Parent Item Name: AS350/AS355 Quick Release Basket/Long Cargo Tube Mounting Provisions, Fits LH/RH

DART SERVICE INSTRUCTION

**TO AMEND INSTALLATION INSTRUCTIONS D350-607-3 Rev. D,
INSTALLATION INSTRUCTIONS D350-607-4 Rev. C AND
INSTRUCTIONS FOR CONTINUED AIRWORTHINESS ICA-D350-607 R**

A	NEW ISSUE		AJS	14.05.16
REV.		DESCRIPTION	BY	DATE
DESIGN	AJS	DART AEROSPACE LTD HAWKESBURY, ONTARIO, CANADA DRAWING NO. DSI 9699 TITLE LUG REPLACEMENT		
DRAWN	AJS			
CHECKED	<i>[Signature]</i>			
MFG. APPR.	N/A			
APPROVED	<i>[Signature]</i>			
DE APPR.	<i>[Signature]</i>	SCALE NTS		
DATE	14.05.16	COPYRIGHT © 2014 BY DART AEROSPACE LTD THIS DOCUMENT IS PRIVATE AND CONFIDENTIAL AND IS SUPPLIED ON THE EXPRESS CONDITION THAT IT IS NOT TO BE USED FOR ANY OTHER PROJECT WITHOUT THE WRITTEN PERMISSION FROM DART AEROSPACE LTD

FIGURE 1: INSTALLATION OF D4775-041 FWD STRUT

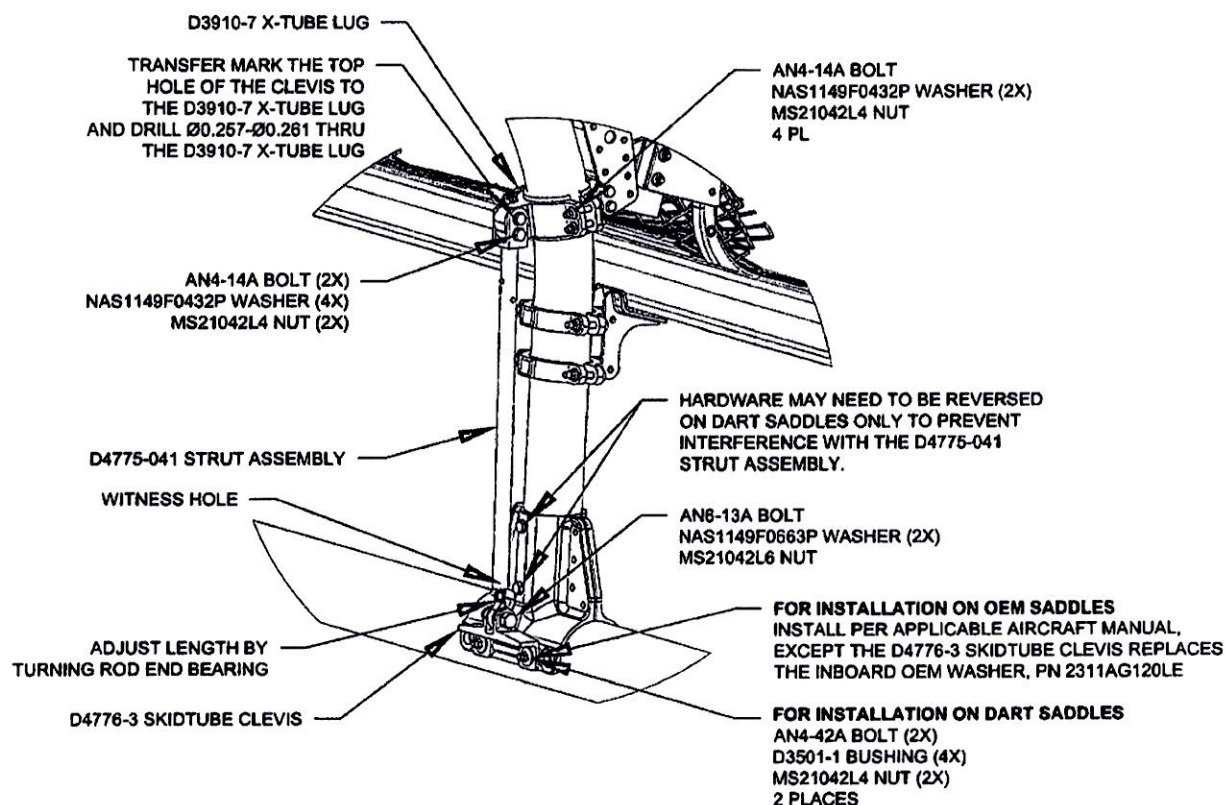
- 3.1 Substitute the Forward Lower D3910-5 X-Tube Lug with the D3910-7 X-Tube Lug as shown in Figure 1.
- 3.2 Install the forward D4775-041 Strut Assembly. Transfer mark from the upper hole on the clevis of the D4775-041 Strut Assembly to the D3910-7 X-tube Lug and drill thru the lug $\varnothing 0.257$ - $\varnothing 0.261$ as shown in Figure 1. Touch up chemical conversion coating per MIL-DTL-5541. Check the witness holes located at the bottom end of the D4775-041 Strut Assemblies to ensure that the thread from the rod end extends past the witness hole.
Torque MS21042L4/-4 nuts to 50-70 in-lbs (5.7-7.9 N-m). Torque MS21042L6/-6 nuts to 160-190 in-lbs (18.1-21.5 N-m).
- 3.3 Complete the installation in accordance with Installation Instructions D350-607-3 Rev. D or D350-607-4 Rev. C.
